# SES SOLAR ONE

In Response to CEC and BLM Data Requests  
49-70, 74, 75, 80, 82-84, and 86-91

Application for Certification (08-AFC-13)

RE: SES Solar One  
Applicant's Responses to CEC and BLM Data Requests Set 1, Part 1  
Data Requests 49-70, 74-75, 80, 82-84, and 86-91

**PROPOSED WATER WELL LOCATIONS  
 SOLAR ONE AND THREE PROJECTS**

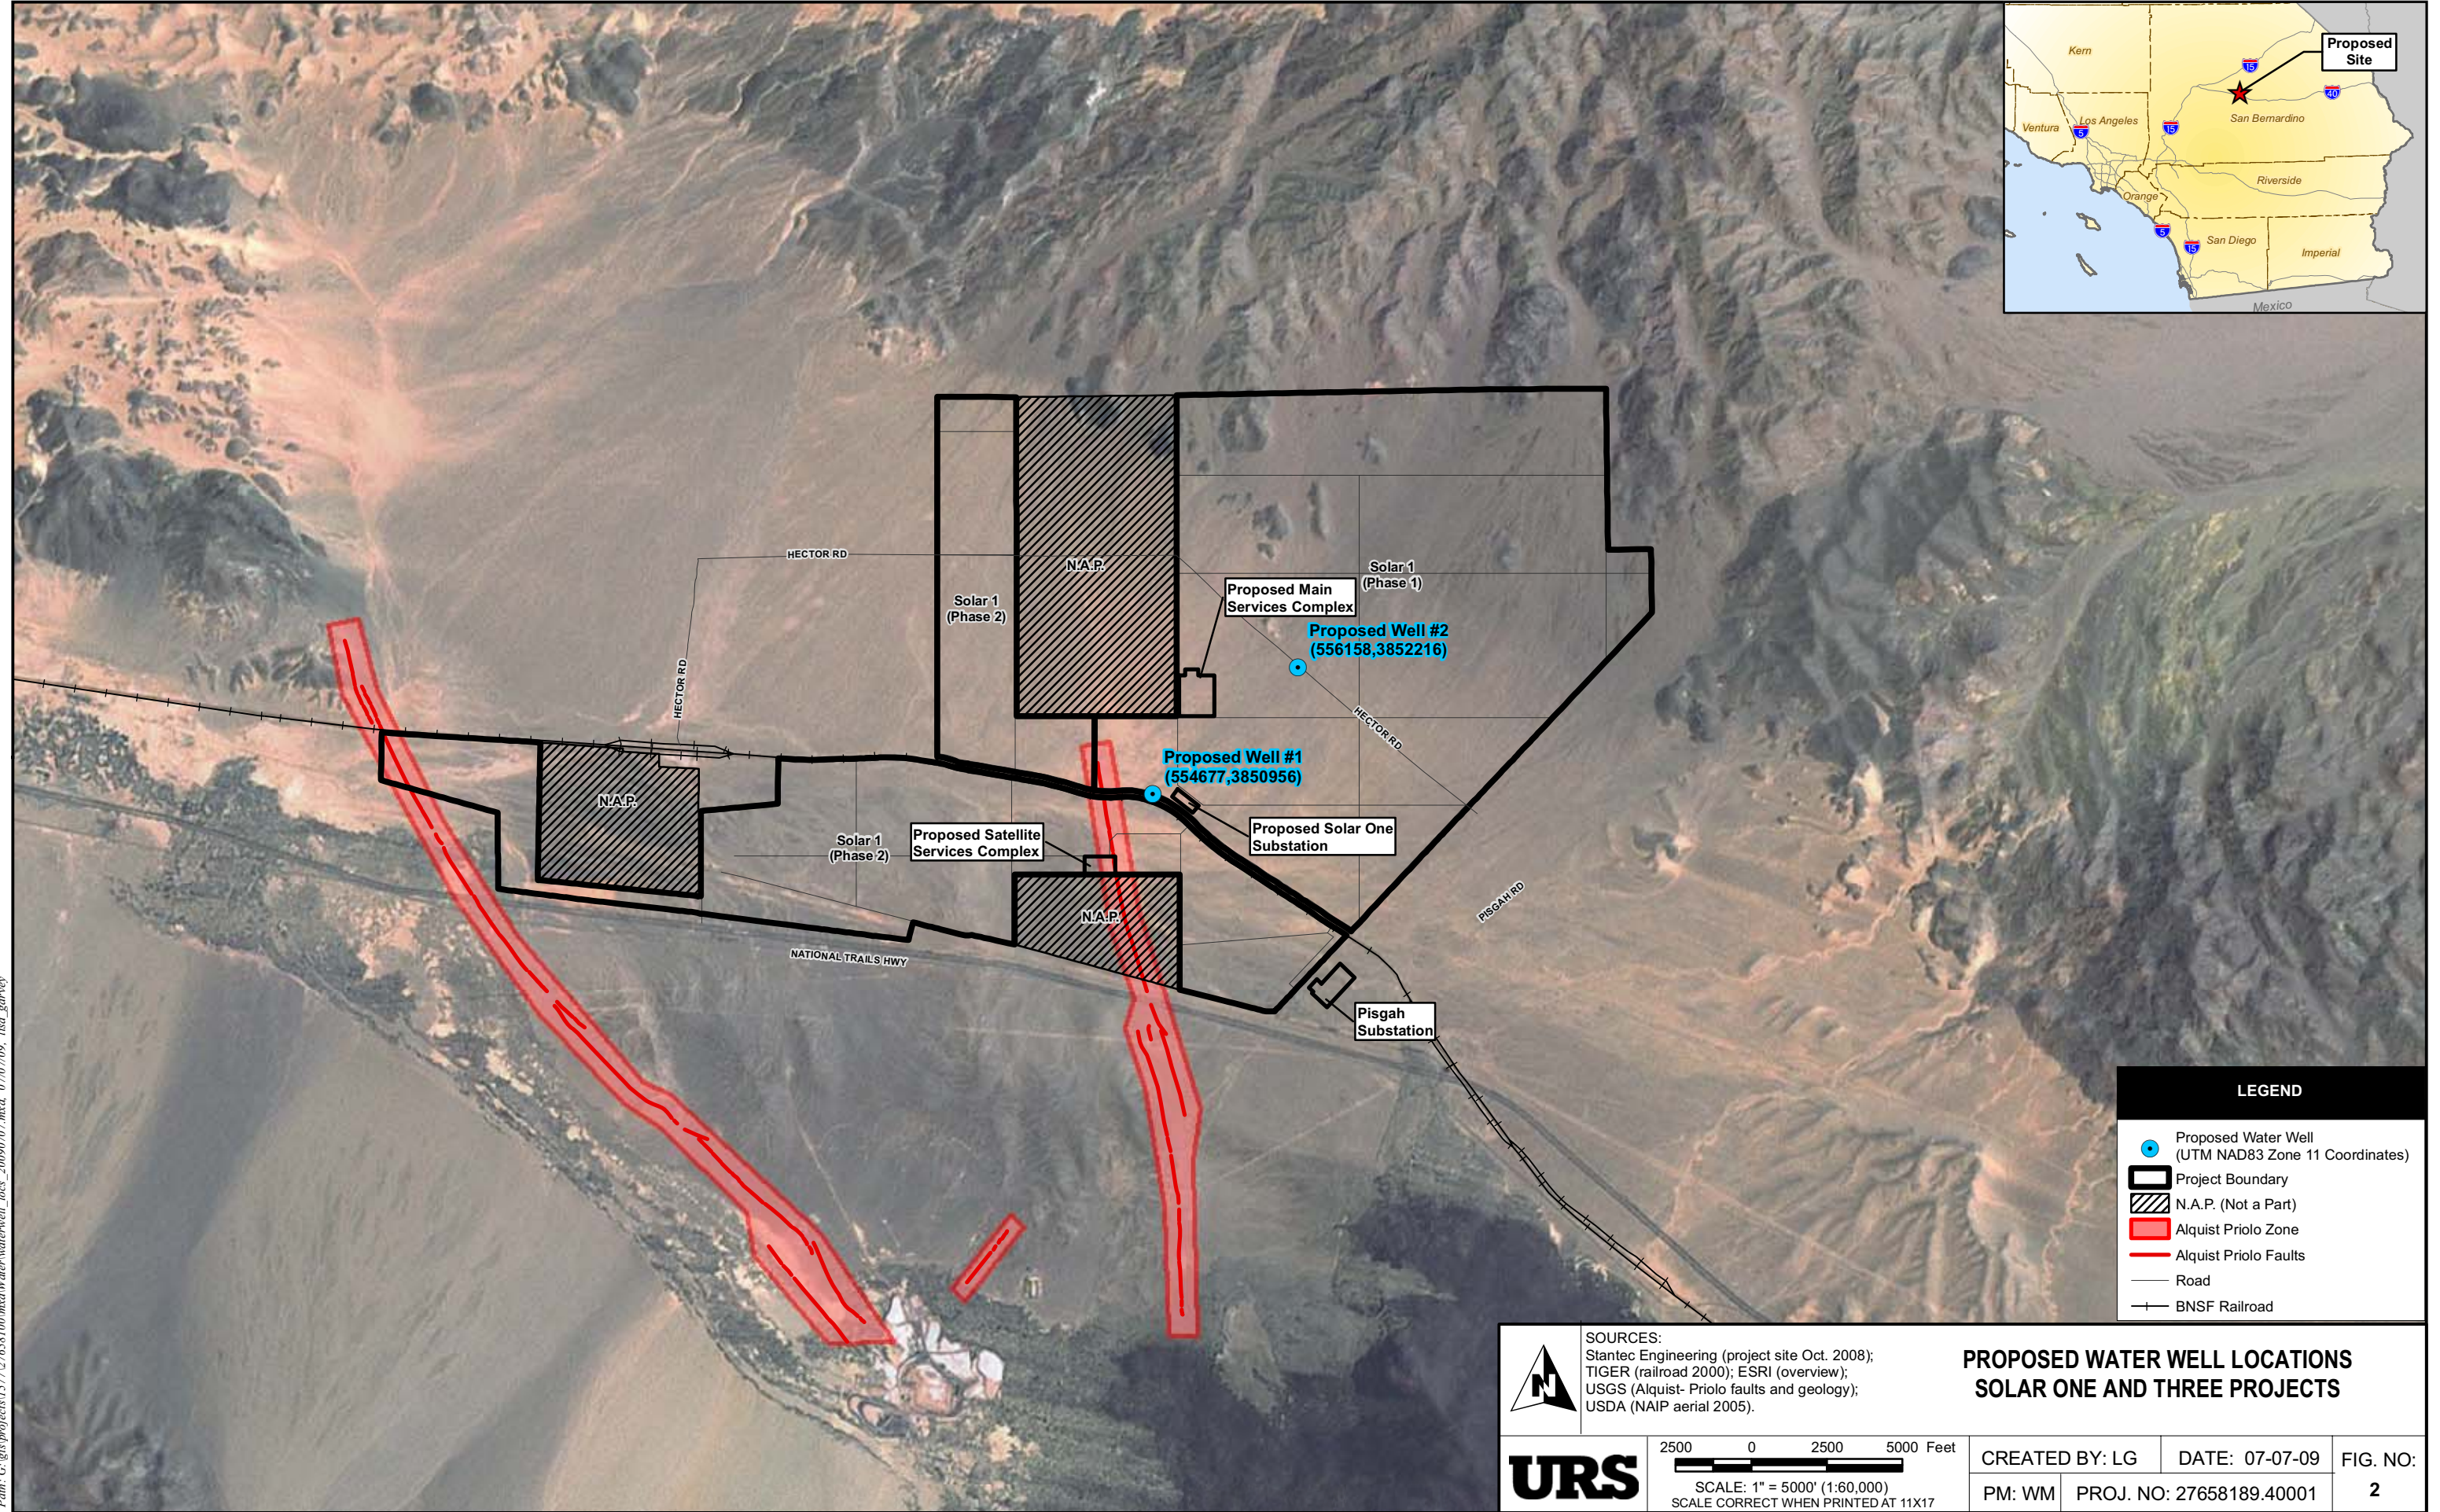
**Data Request 70:** If the wells are different from each other, please identify the locations of the wells and indicate which well is proposed for project use.

**Primary Water Well:** Based on the current condition and limited water column in the existing wells, it is anticipated that another well or wells would be needed to provide water supply for facility construction and operations. It is this well or wells that will be installed that are referred to as “primary wells” in the AFC (locations shown on SWR-2).

**Response:** The locations of the existing wells are shown on SWR-1, as described above. The Adjacent Well is located in T9N, R5E Section 33. The Nearby Existing Well is located T8N, R5E Section 1. Both wells are not operational in their current condition. There are two proposed locations for the installation of water supply wells. The preferred location (labeled on SWR-2 as Proposed Well #2) is shown on SWR-2 and is located in T8N, R6E Section 6.
